**City of Bellevue
Development Services Department
Land Use Staff Report**

Proposal Name: Li Short Plat

Proposal Description: Land Use Review of a Preliminary Short Plat application to subdivide an 18,606 square foot lot creating one new lot on this property zoned R-4.

File Number: 13-117661-LN

Figure 1

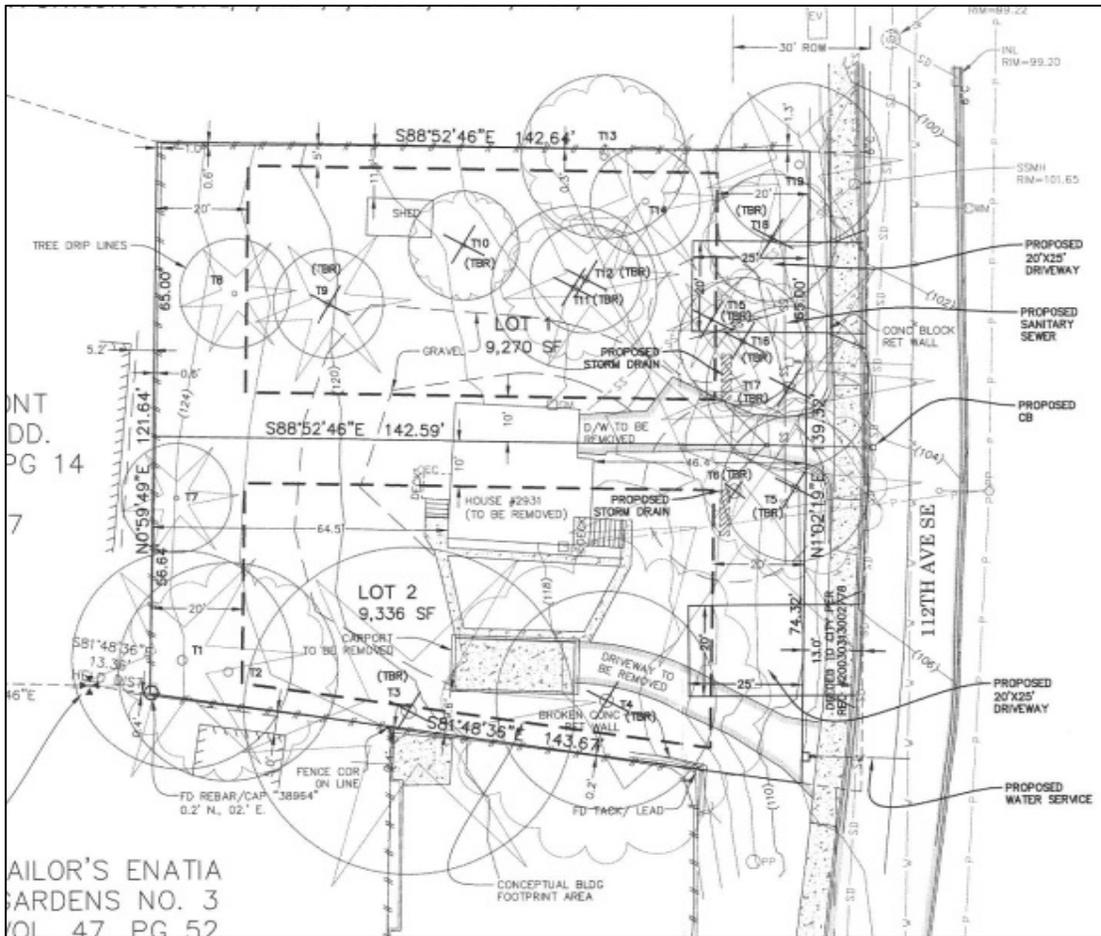
Lots one and two will be from a private driveway connection to 112th Avenue SE as shown on the approved plans with modifications (at the direction of the Transportation Department to be addressed during the clear and grade phase for this project). No other access connection to city right-of-way is authorized. The existing driveway which serves the existing house must be removed. Street frontage improvements matching adjacent improvements must be provided at the location of the removed driveway.

Minimum private driveway widths are 10 feet will be a minimum of sixteen feet with Fire Department Approval and must be built per the City's Transportation Department Design Manual Standard Drawing DEV-7A.

Existing street frontage improvements adjacent to the project site include curb, gutter and six foot wide sidewalks. These frontages are in satisfactory condition and do not require repair or replacement. In lieu of right of dedication to accommodate city project B-215-W (wide bike shoulder on the west of side of 112th Avenue SE) the applicant will be required to grant the City a construction, maintenance, and pedestrian easement along the entire eastern property line of the project site. **See related conditions of approval in Section X of this report**

The access design shall meet the sight distance requirements of BCC 14.60.240. Vegetation shall be trimmed as needed within the sight triangle. If needed the applicant will be required to modify adjacent embankments and keystone walls to meet sight distance requirements. **See related conditions of approval in Section X of this report**

- a. Site Specific Items:
 - i. Granting of a ten foot wide construction, maintenance and pedestrian easement along the eastern property line of the project site.
 - ii. Modifications to the existing embankments and keystone walls located along the eastern property line of project site necessary to comply with sight distance requirements.
 - iii. Removal / replacement of existing driveways to match existing frontage on 112th Avenue SE.
 - iv. Pavement restoration limits.

- v. Driveway connections per DEV-7A. Driveways must connect to 112th Avenue SE at a 90 degree angle, have a clear distance of 20 feet from all adjacent driveways (measured from point A of DEV-7A) and be contained within the site's frontage along 112th Avenue SE.
- b. Miscellaneous:
 - i. Landings on sloping approaches are not to exceed a 10% slope for a distance of 20 feet approaching the back edge of sidewalks. Driveway grades must be designed to prevent vehicles from bottoming out due to abrupt changes in grade.
 - ii. The maximum cross grade of a street at the street end shall be 8%.
 - iii. Vehicle and pedestrian sight distance must be provided per BCC 14.60.240 and 14.60.241.

LI SHORT PLAT
PRELIMINARY SHORT PLAT

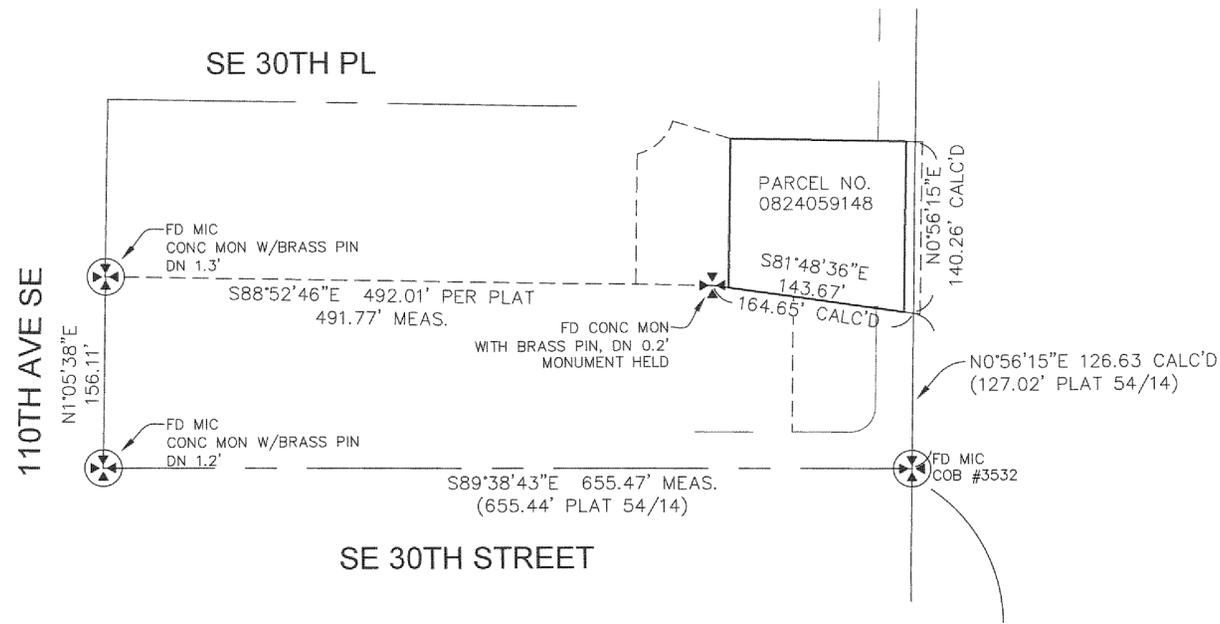
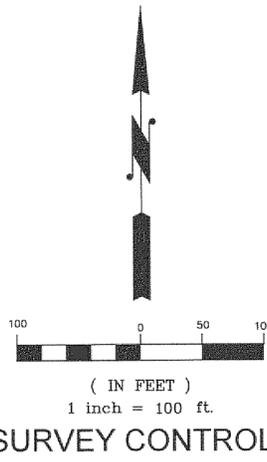
- B. Significant Tree Preservation:** *Tree preservation requirements pursuant to LUC Section 20.20.900.D require the retention of 30% of significant trees on the site. In order to meet the 30% minimum retention requirement, the project must retain a minimum of 118 diameter inches of the existing significant trees.*

Response: The applicant proposes to preserve at least 118 diameter inches which satisfies the minimum 30 percent tree retention requirements. **See related conditions of approval in Section X of this report.**

1. Clearing limits, including limits of any soil disturbance, shall be established at the BSBL for all retained trees.
2. Minimum four (4) foot temporary chainlink fence shall be installed at the limits of disturbance. Protective fence shall completely encircle the retained trees, following the BSBL for each lot, and then the tree's dripline to the perimeter of the parcel. Install fence posts using pier block only.
3. The area within the protective fencing shall be off limits to any materials storage or foot traffic. No stockpiling of materials, vehicular or pedestrian traffic, material storage or use of equipment or machinery shall be allowed within the protective fencing. Fencing shall not be moved or removed, except for sidewalk construction, unless approved by a City planner. Any work, activity or soil disturbance

At least thirty percent of the diameter inches of all significant trees on the site are required to be retained. If trees depicted on the preliminary short plat as retained are subsequently found infeasible to retain, conformance is required to be demonstrated with LUC 20.20.900 D and/or G to demonstrate that the required 30 percent of diameter inches is being retained.
